## Modification to run CPU09CMI on 4MHz bus.

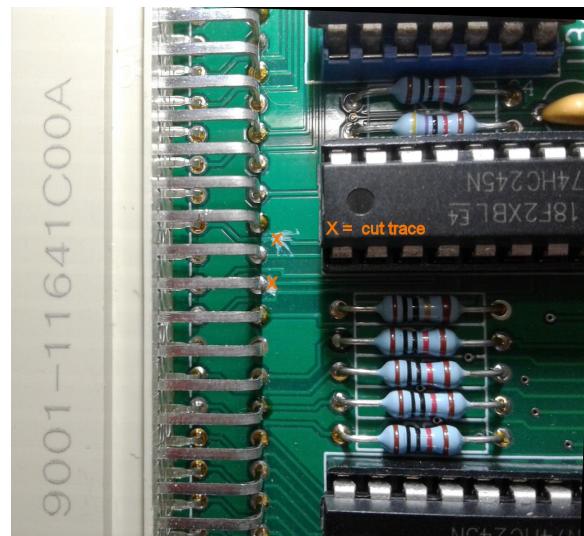
Replace xtal into 16MHz.

Replace C1 and C2 by 15pF.

Place 10M smd between crystal pins.

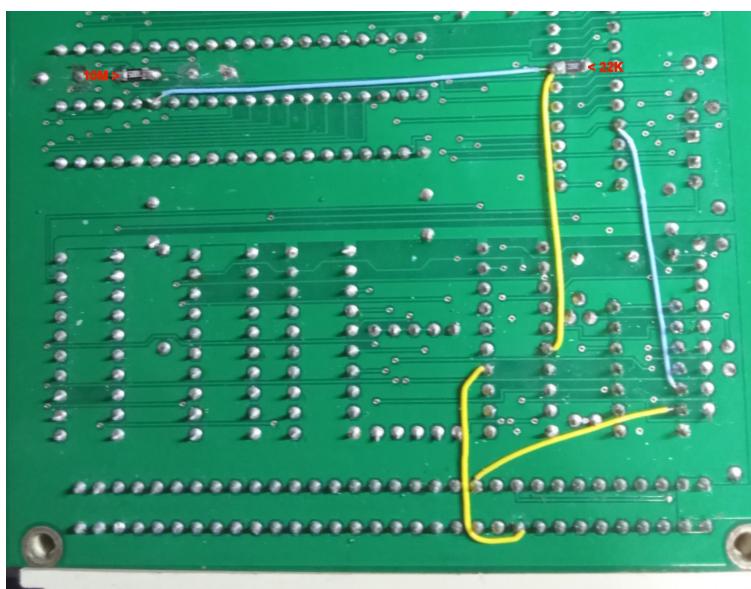
Cut trace between U13-19 and via (OVMA-)

Place 22K resistor between U13-19 and Gnd

Place wire from U6-35 to U13-19 (blue) and U4-6 (Q) (yellow)

Place wire from U4-14 to J1 A-23 (B\_Q) (yellow)

Place wire from U3-7 to J1 C-21 (B\_VMA-) , Or:

**To keep CPU09CMI 68x02 compatible  
or need VMA- signal with 68x02 on the bus  
for CPU09GPP or CPU09RAM card.**

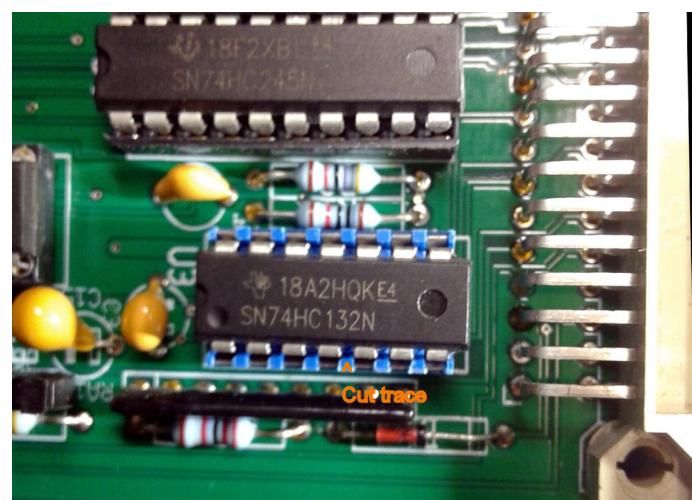
Cut trace between U3-4 and U3-5

Place wire from U3-5 to U13-9 (VMA) (blue)

Place wire from U3-6 to J1 C-21 (B\_VMA-) (yellow)
